SP2023-002

CONSTRUCTION PLANS FOR SCREENING AND BUFFERING

SCREENING AND BUFFERING
Overall Layout Plan
Discovery Lakes Ph. 1
City of Rockwall, Rockwall County, Texas

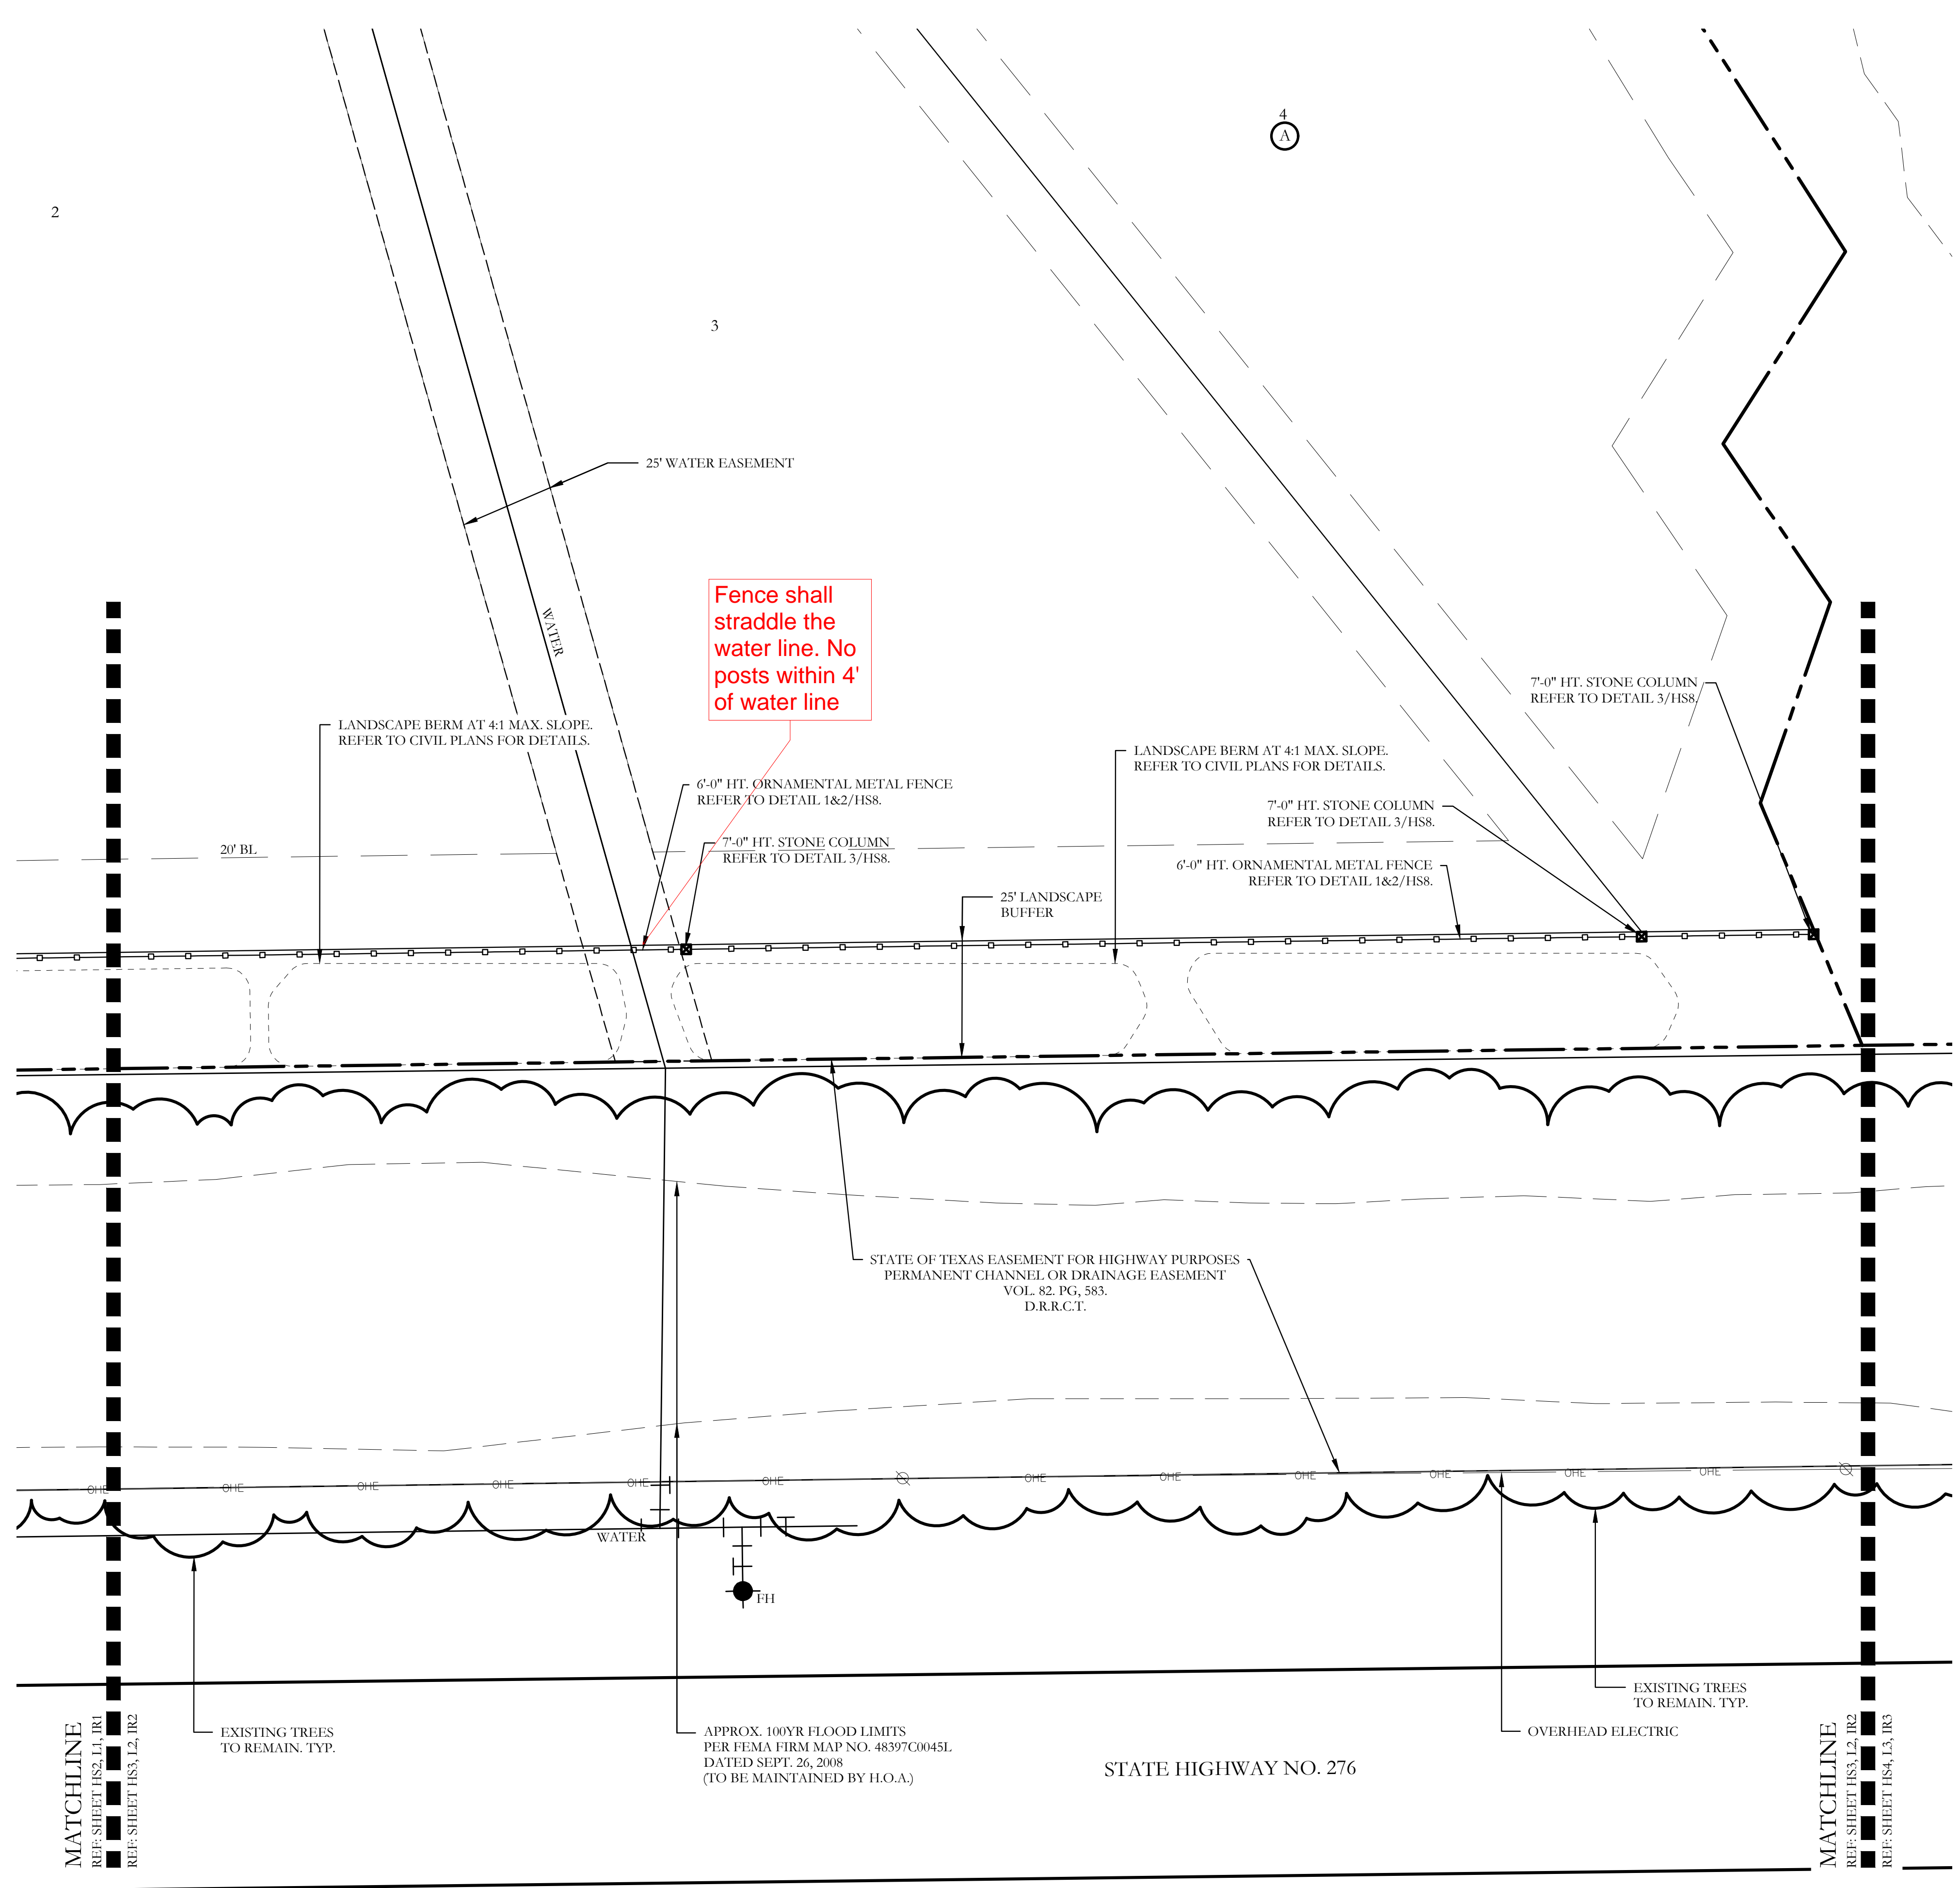
Fence shall
straddle the
water line. No
posts within 4'
of water line
